**SUBJECT: CONDITIONAL USE / CLASS 3 SITE PLAN REVIEW / CLASS 2 DRIVEWAY APPROACH PERMIT / CLASS 1 DESIGN REVIEW CASE NO. CU-SPR-DAP-DR22-07
2410 FAIRGROUNDS ROAD NE - 97301
AMANDA NO. 22-117397-PLN**

Summary: Phased development of a motor vehicle sales use and motor vehicle services use, with vehicle display and vehicle storage areas.

Site Plan Review Class 3
 Creative Credit & Auto Sales
 2410 Fairground Rd NE

EXISTING SITE PLAN
 SPR-1
 SCALE: 1" = 30'-0"
 0' 3' 15' 30' 60'

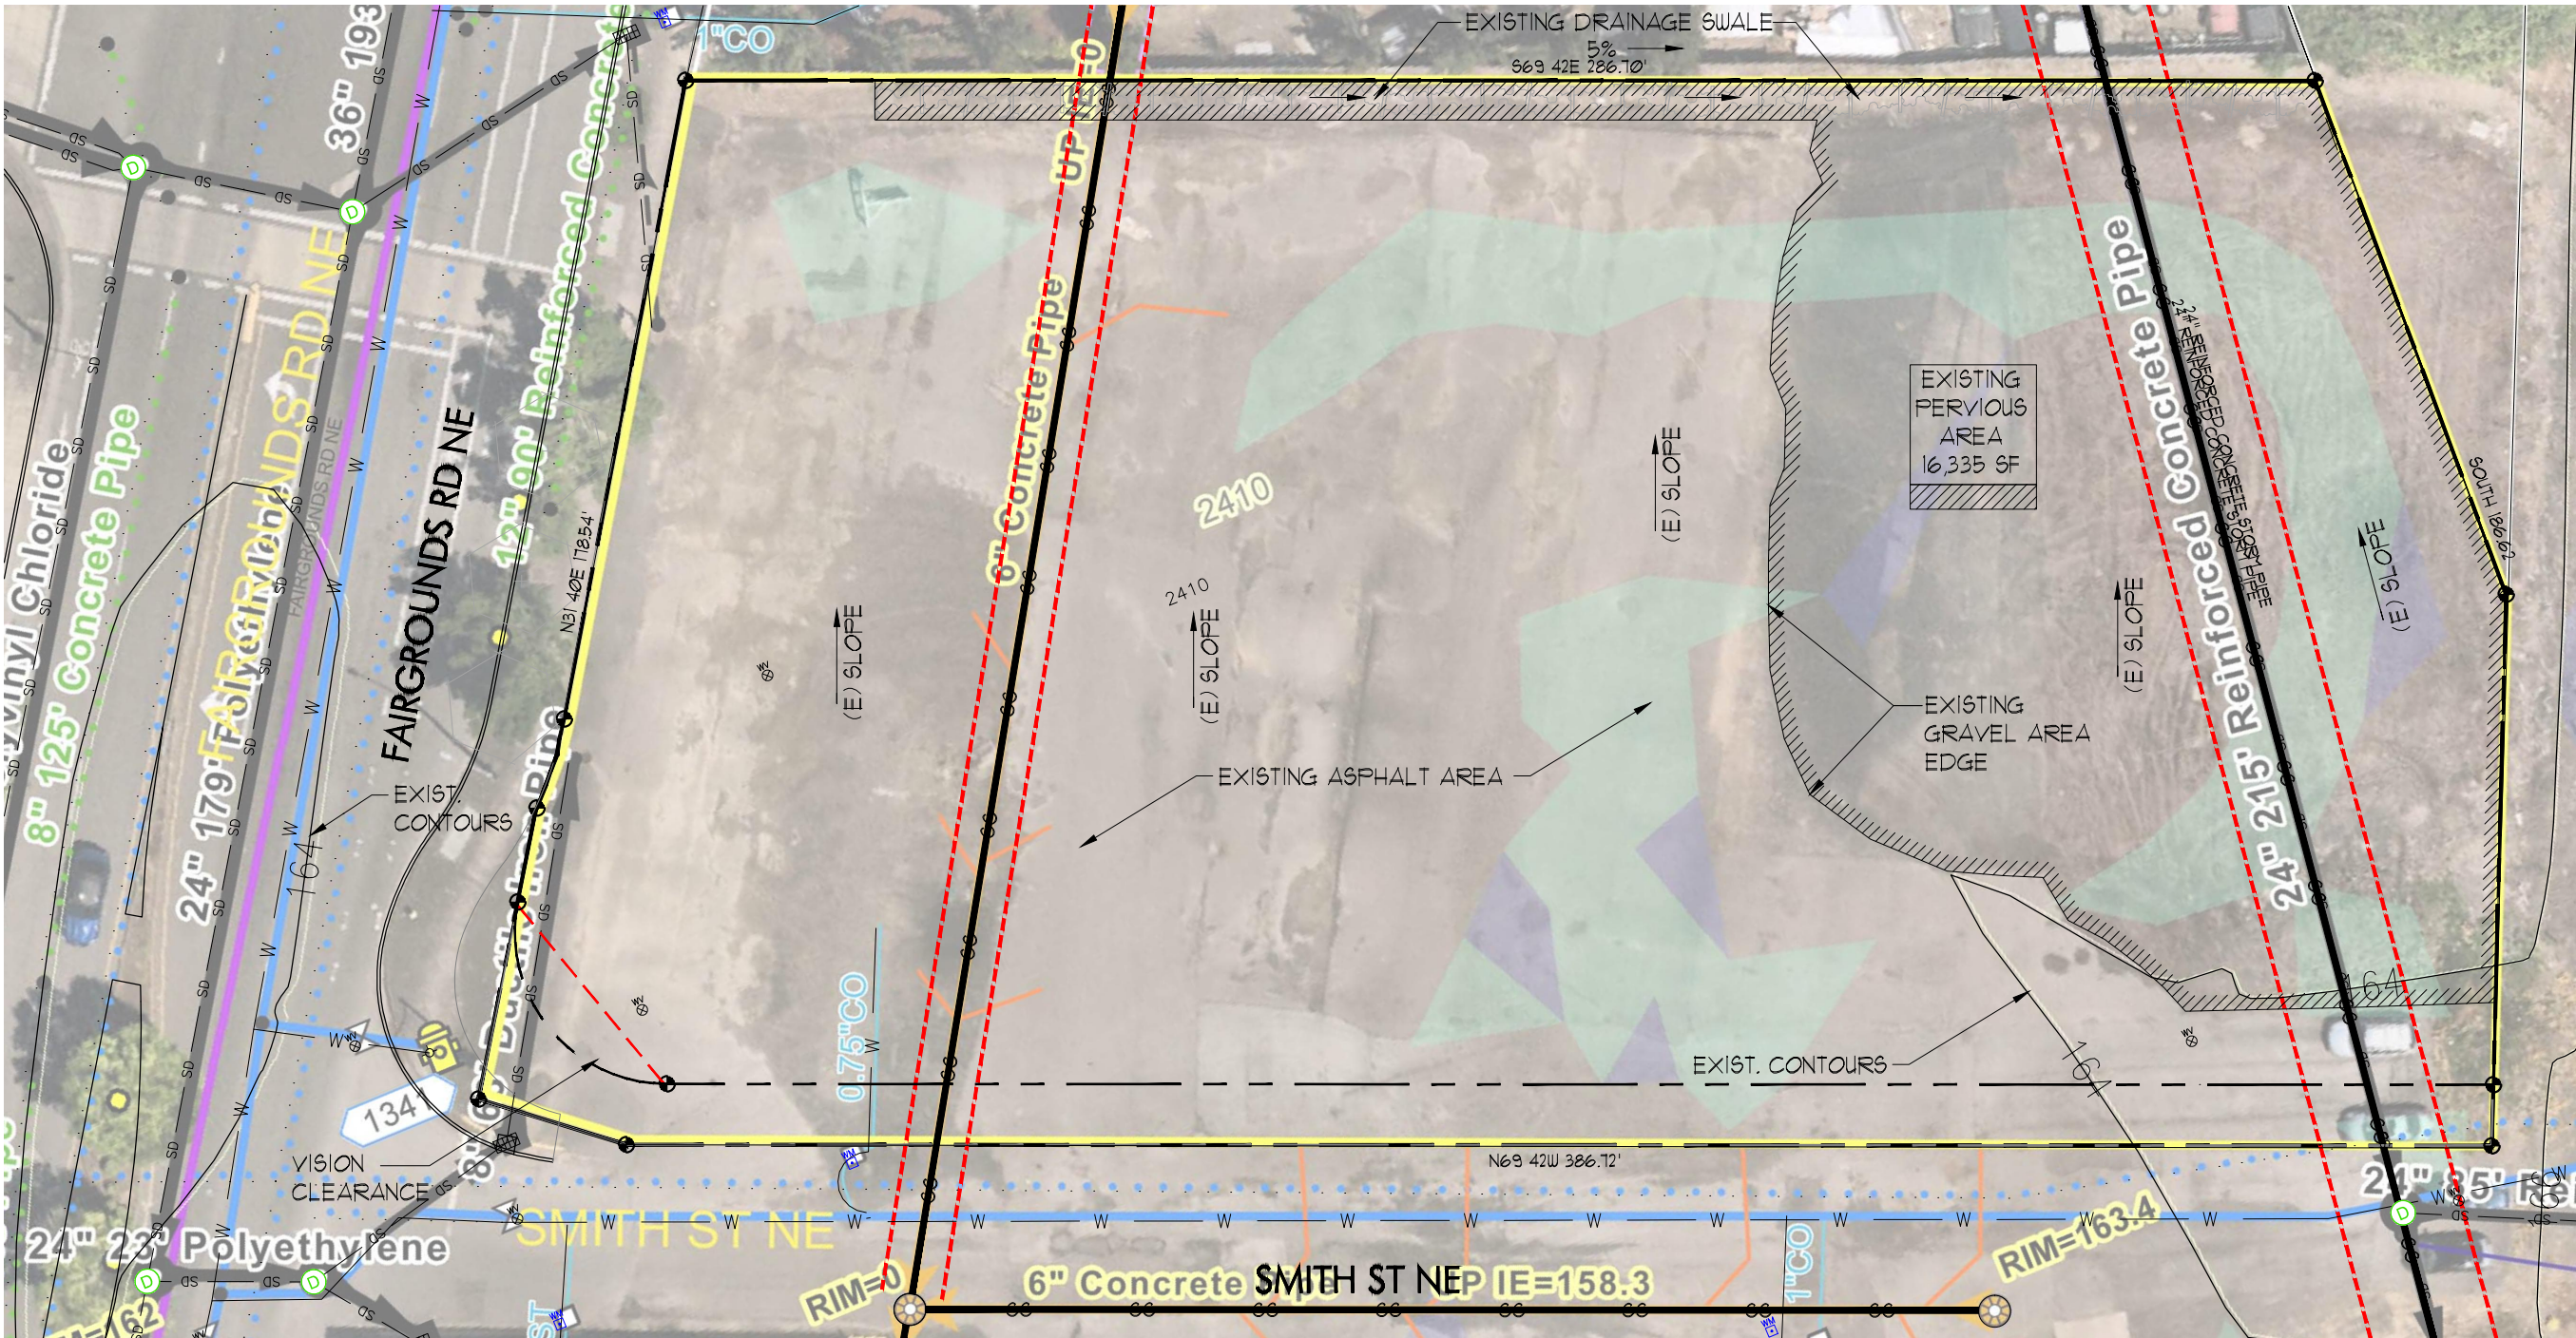
It is unclear from the submitted plans whether or not the proposal meets the definition of a large project pursuant to SRC 70.005. Based on preliminary review of the plans, staffs understanding is that the applicant is proposing ~13,000 SF of impervious surfaces to replace existing gravel surfaces, which would trigger the stormwater requirements for a Large Project. The applicant shall submit more clear plans showing the existing conditions versus what is proposed and a written findings regarding the definition of large project and new/replaced impervious surfaces pursuant to SRC 70.005.

Site areas have been adjusted; we are adding less than 10,000 sf of new impervious area. See existing conditions plan SPR-1 and SPR-2 proposed plan for the areas.

PROPOSED SITE PLAN

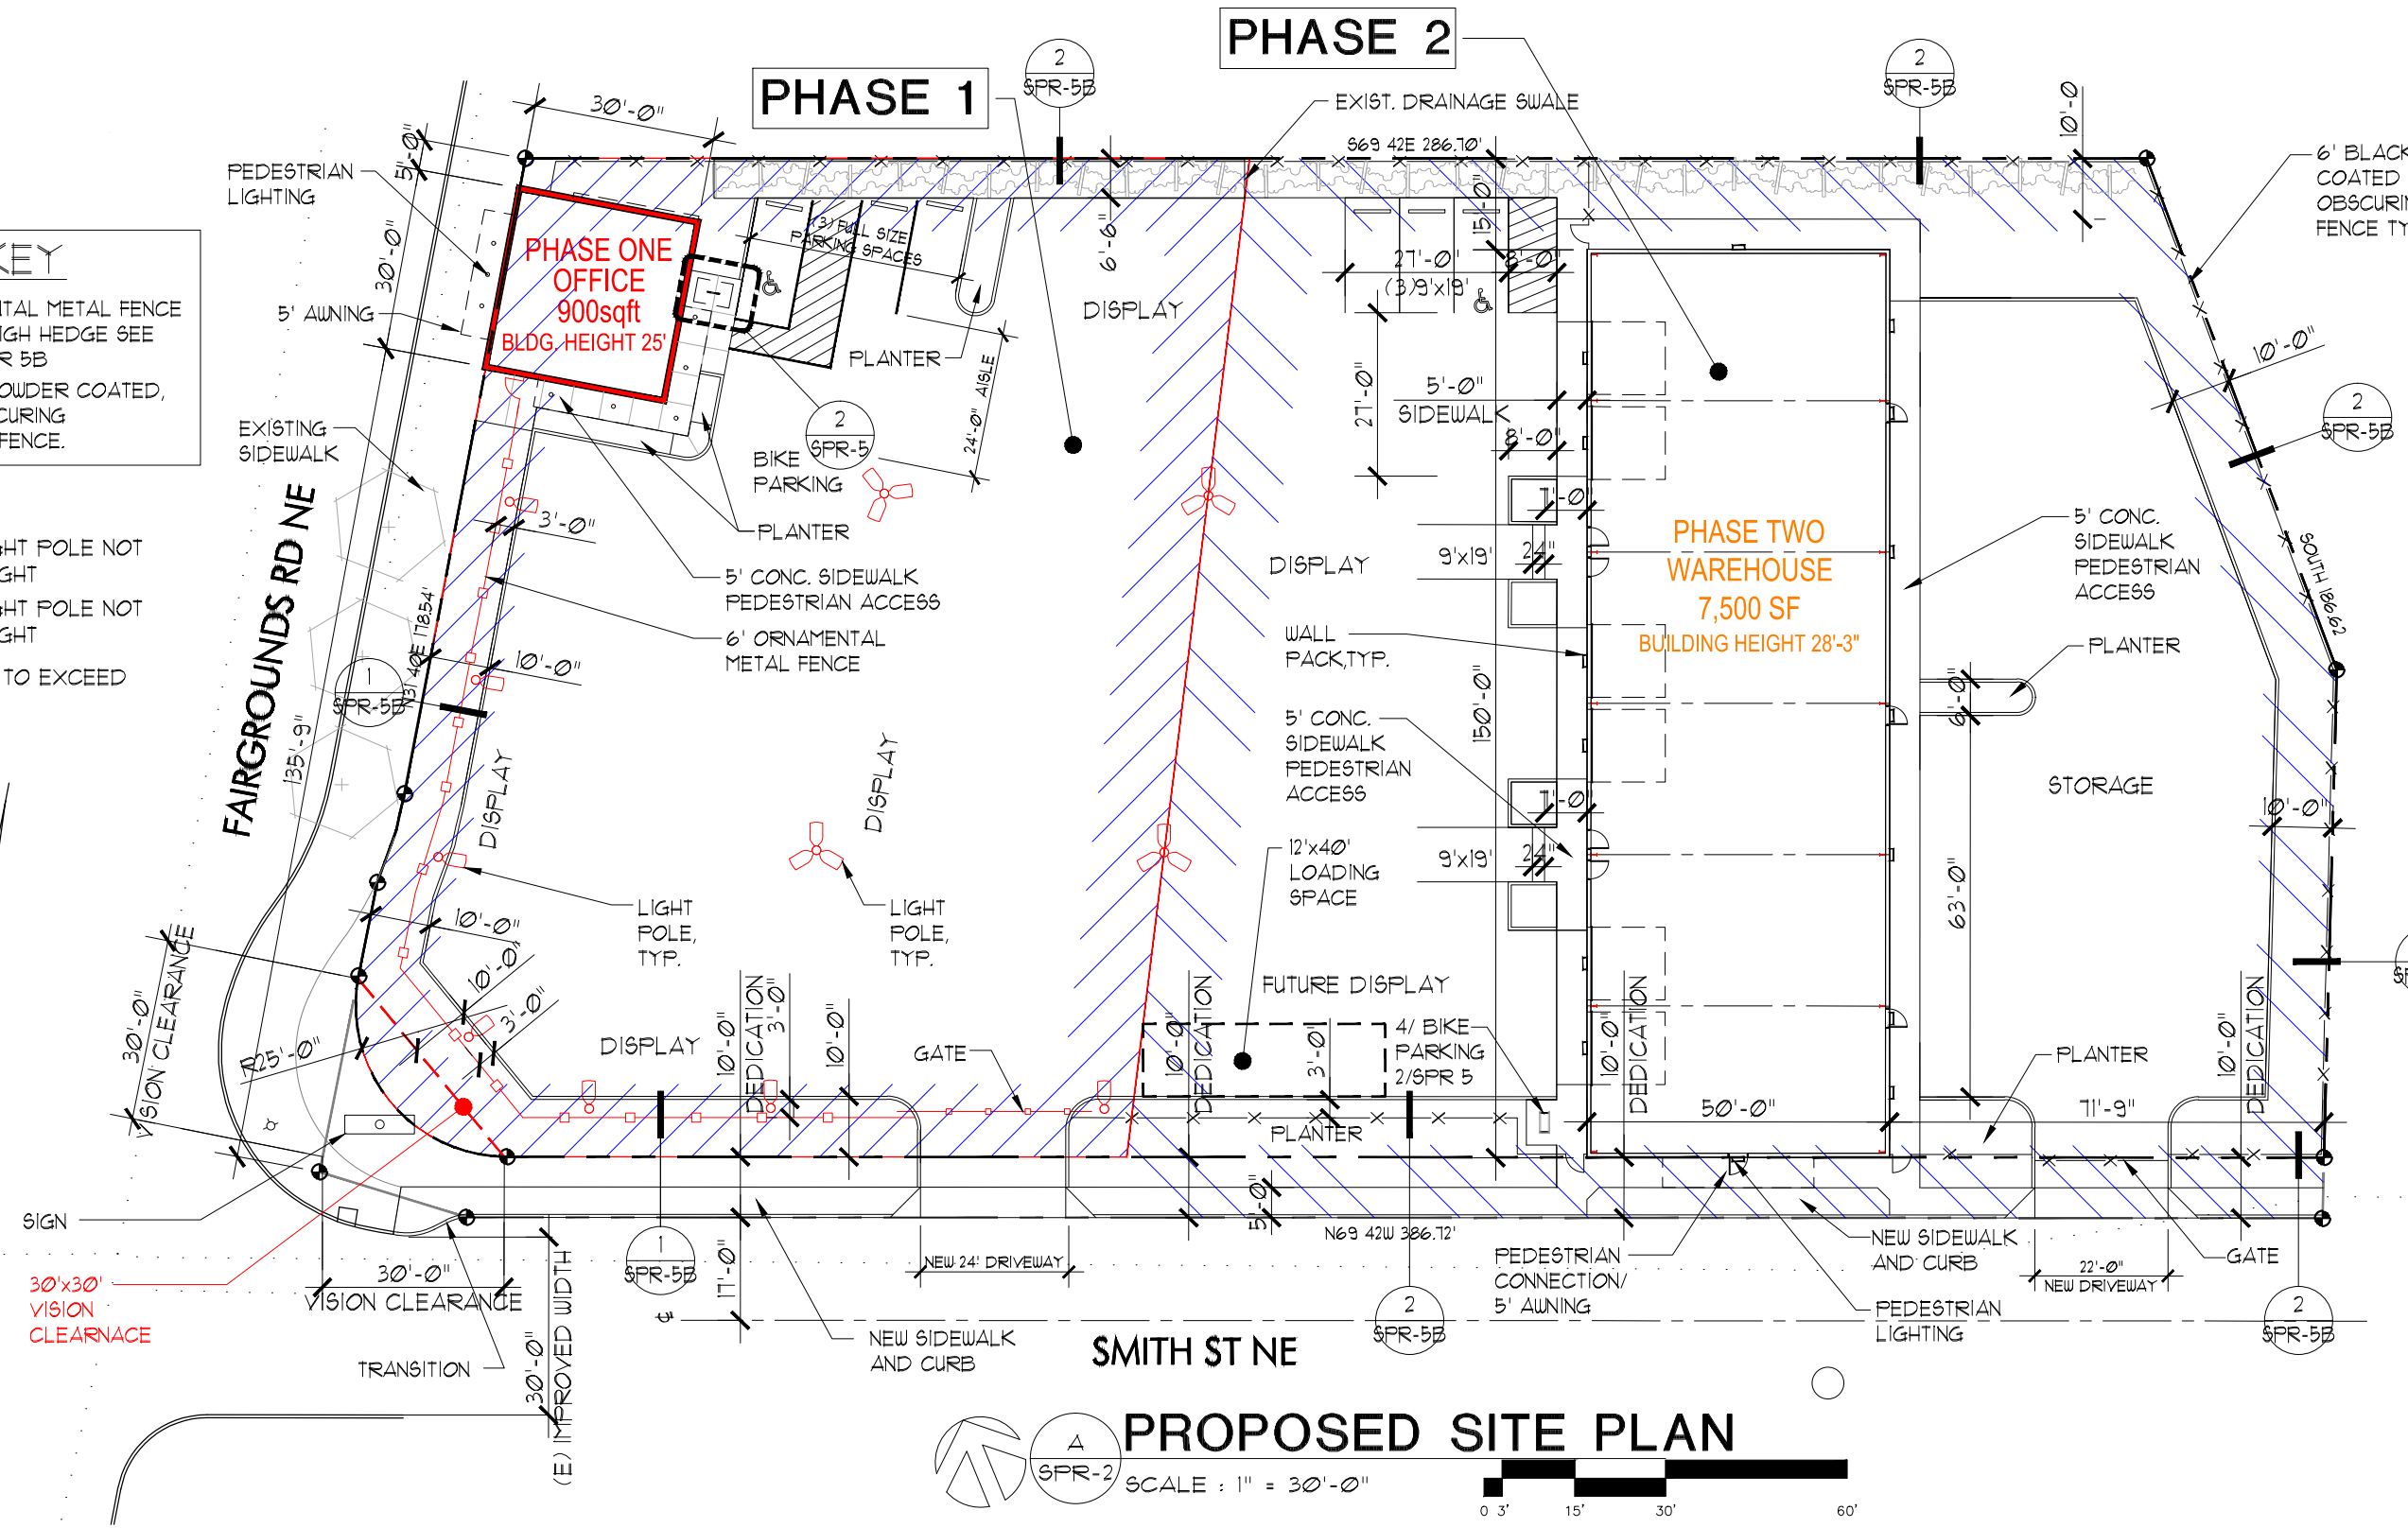
The maximum parking allowance for Phase 1 is three parking spaces, the proposed site plan shows four spaces.

The proposed site plan has been revised for the required setback. See the revised sheet SPR-2

The plan now shows 3 parking spaces. See sheet SPR-2

We are indicating 8 total spaces for both Phase 1 and Phase 2. See sheet SPR-2.

1 ORNAMENTAL METAL FENCE DETAIL

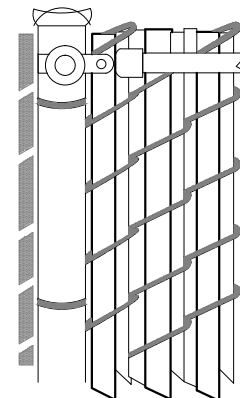
Style of sight obscuring fencing not indicated in plans or narrative.

The display is screened with a 6 foot high ornamental metal fence and a 3 foot high hedge per detail 1/SPR-5B. See fence key on sheet SPR-2 for fence types and locations. See detail 2/SPR-5B for the 6 foot high black powder coated sight-obscuring chain link fence.

A
SPR-6
LANDSCAPING PLAN

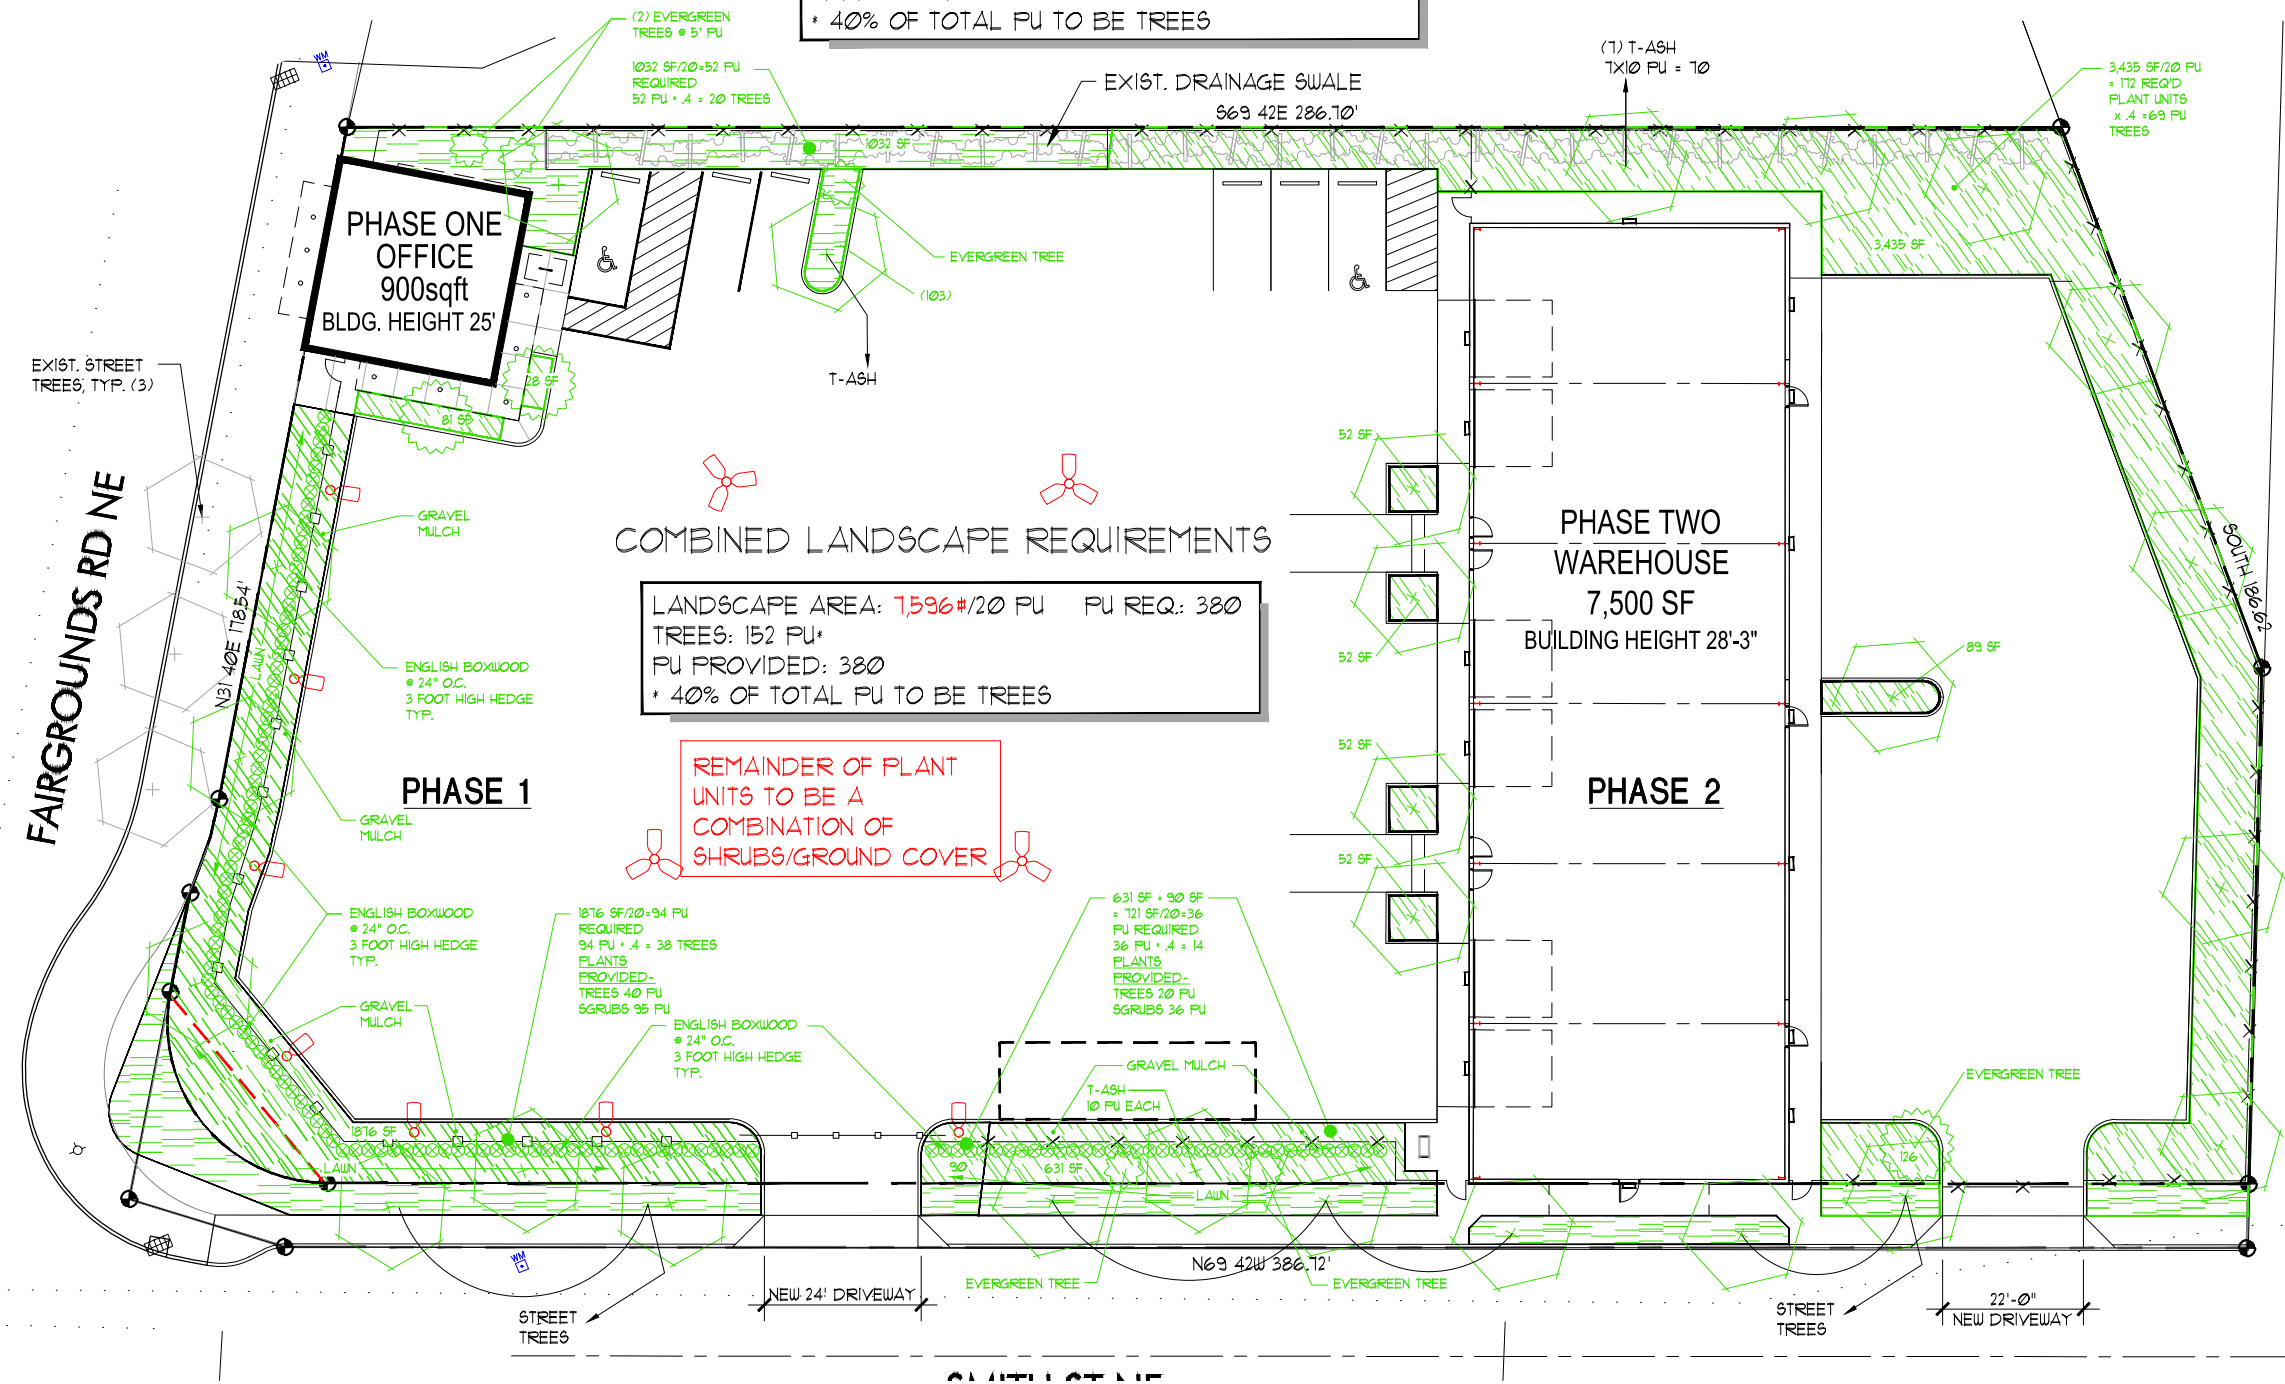
Per SRC 604.020(g)(1), planter bays or islands shall have a minimum planting area of 50 square feet.

Proposed planter islands proposed are less than 50 square feet in size and shall be revised to comply with the minimum standard.

Planter bays are 50 sf min. each. See sheet SPR-6.
